MIL-PRF-19500/496B
AMENDMENT 1
25 March 2001

PERFORMANCE SPECIFICATION SHEET

SEMICONDUCTOR DEVICE, TRANSISTOR, DUAL, PNP, UNITIZED,
SILICON, TYPES 2N5795 2N5796, AND 2N5796U, JAN, JANTX AND JANTXV

FIGURE 3. Switching time test circuits. ”

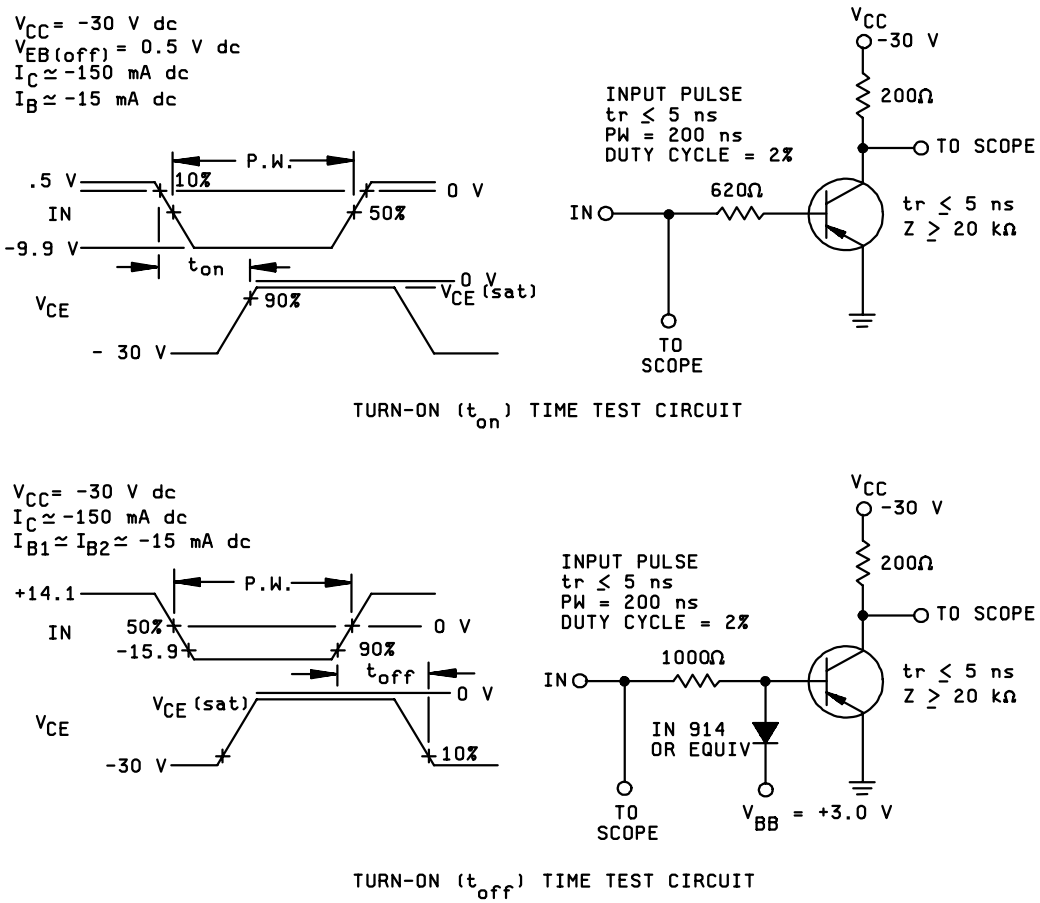
FIGURE 3, delete and substitute:
